To: James L. App, City Manager

From: Ron Whisenand, Community Development Director

Subject: Riverside Avenue Sidewalks: Parking Lot Fence Design

Date: September 7, 2010

**Riverside Avenue Sidewalks Project
Site Plan**

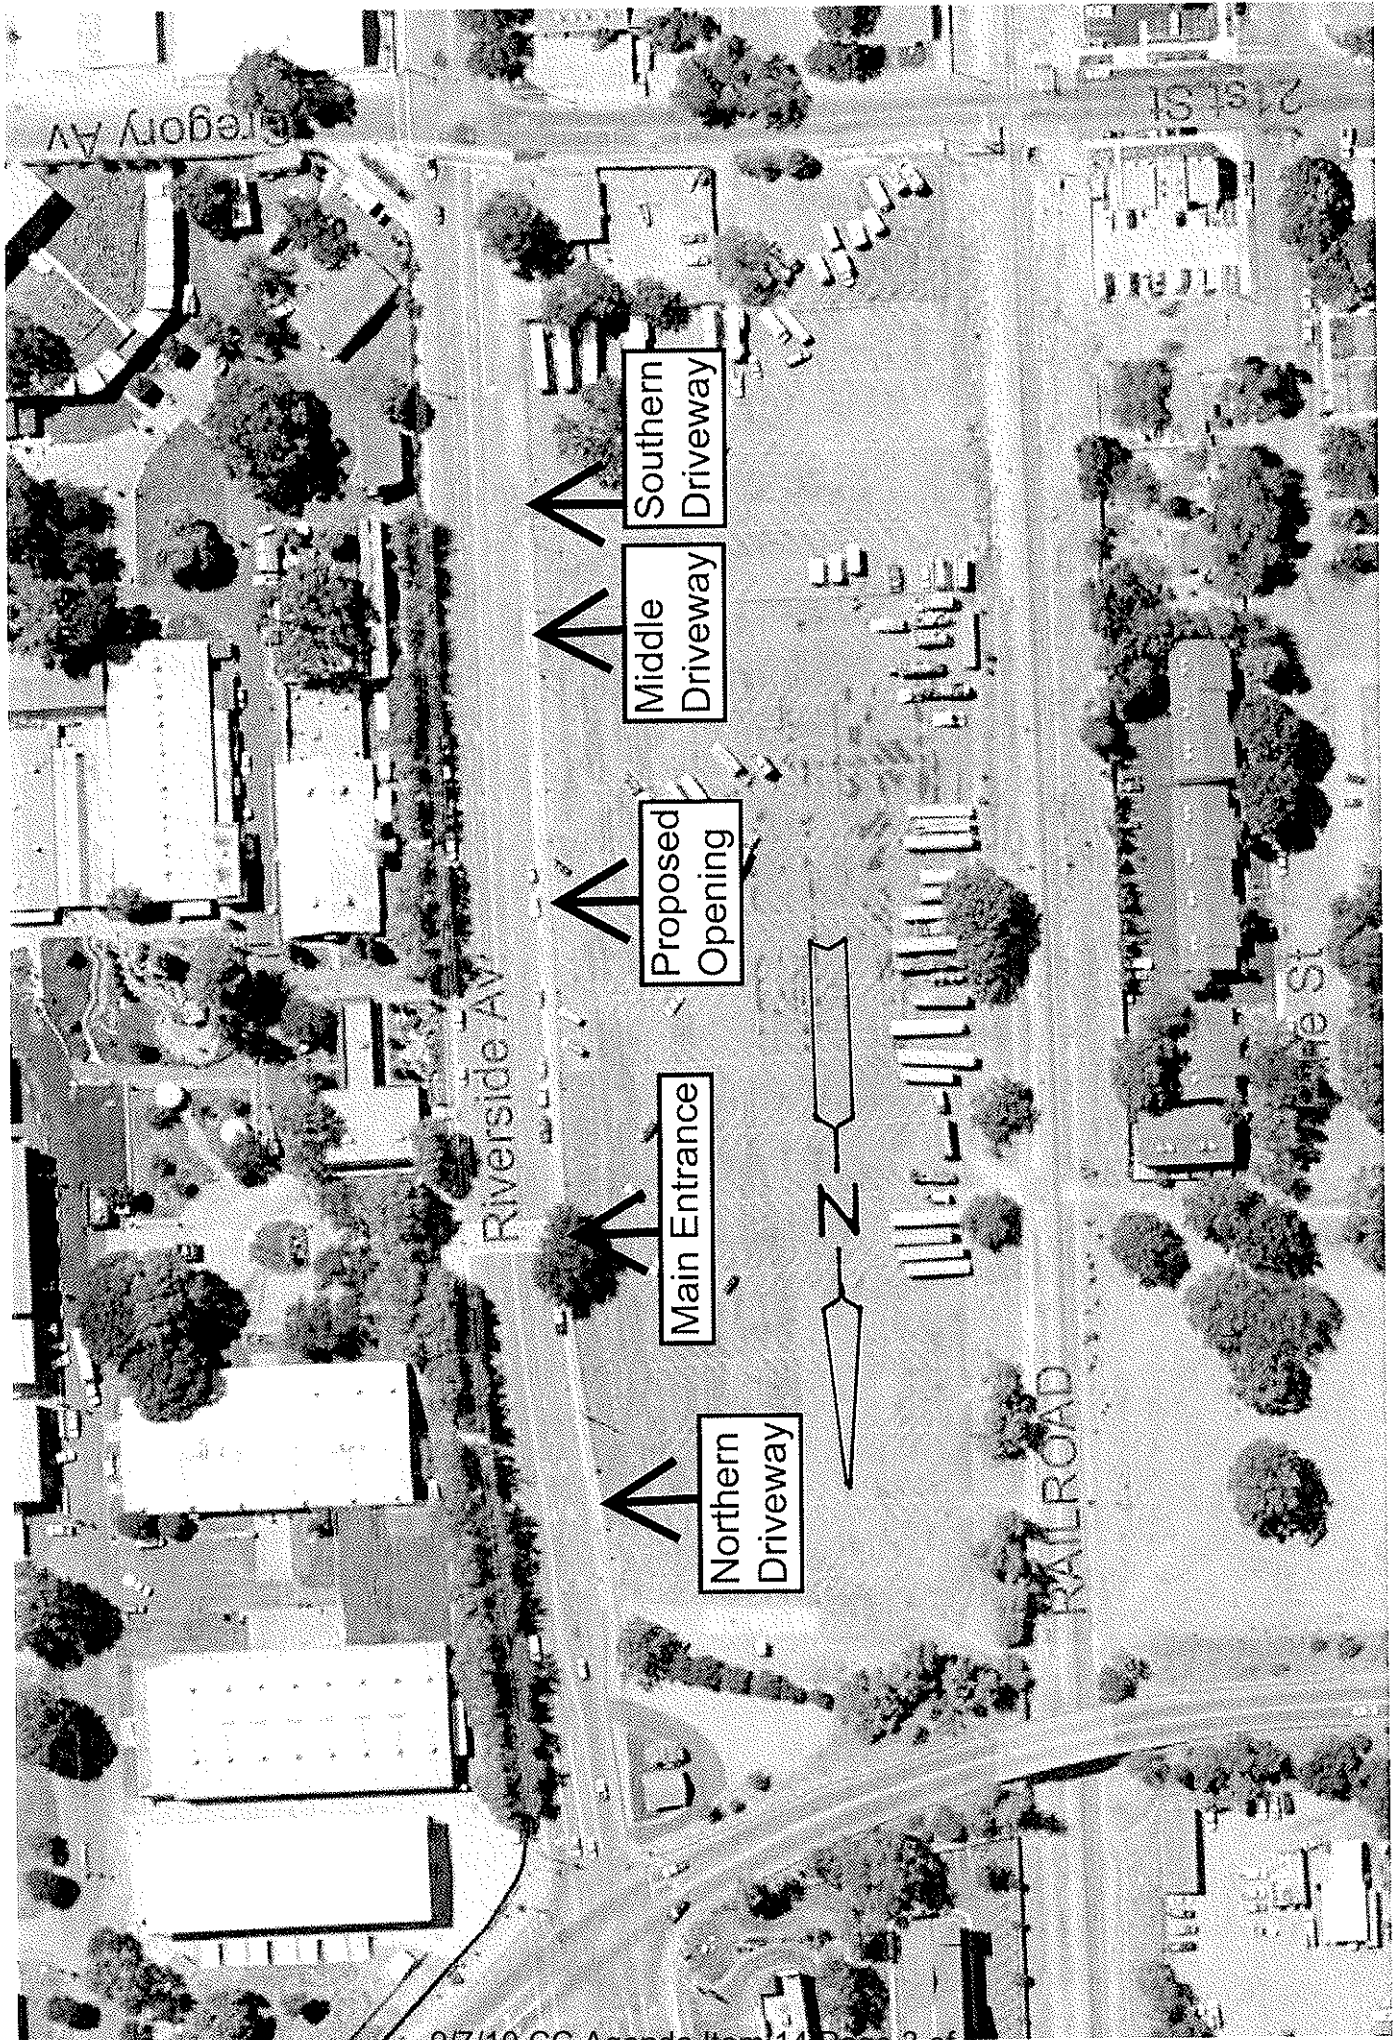
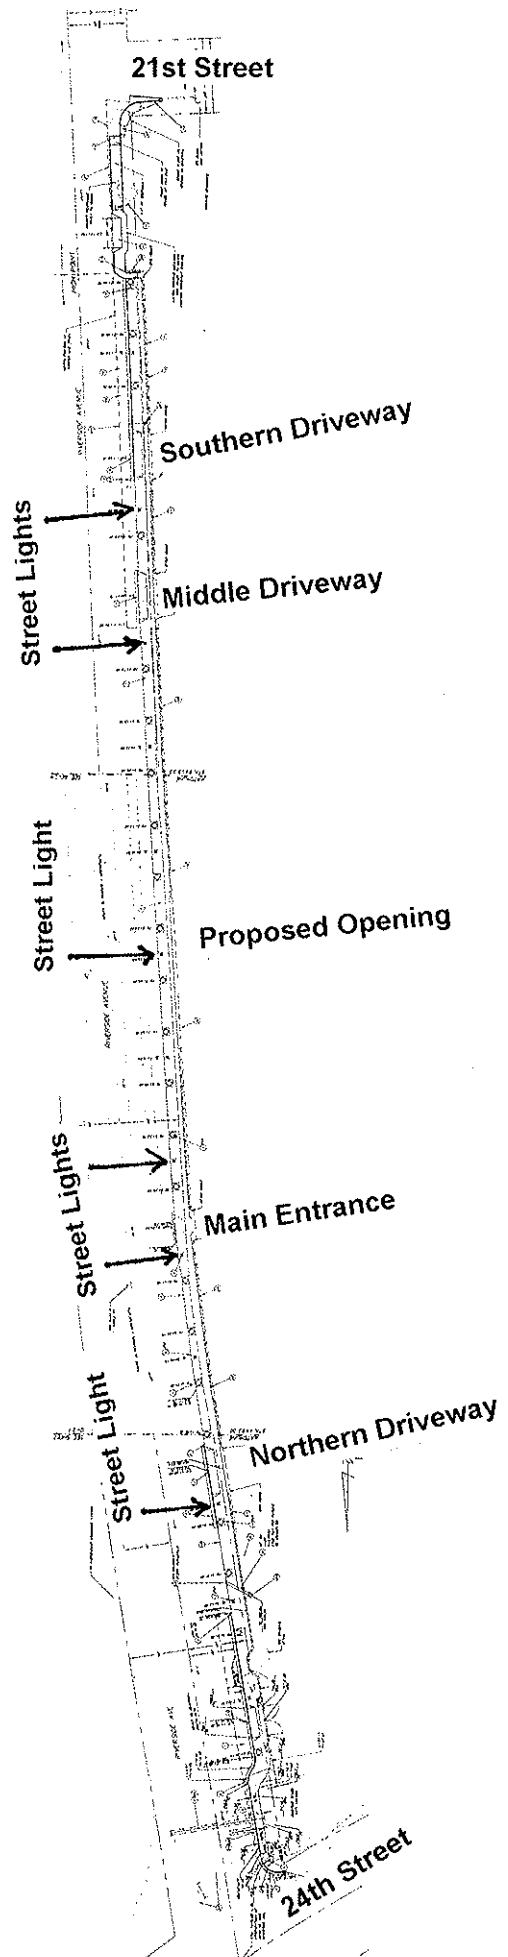
4. It is proposed that the fence design, which presently only provides for a single pedestrian opening opposite the Main Entrance to the PREC, be modified to add the following 4 foot wide openings:

- a. Both sides of the northernmost driveway;
 - b. Approximately 200 feet south of crosswalk to main entrance of PREC; *
 - c. North side of the middle driveway;

- d. Both sides of the southernmost driveway (in the "Oak Tree Lot").

* This location is halfway between the opening across from the Main Entrance to PREC and the middle driveway; it would be about 70 feet north of the present opening.
5. Attached are an aerial photo and site plan showing the proposed locations of the openings, and a detail of the fence design.
6. Additionally, it is proposed that posts with rings to accept wire cables be placed on the outer edges of all driveways (noted as items "4a", "4c", and "4d",

above) so that the driveways might be closed, but the pedestrian openings left open.
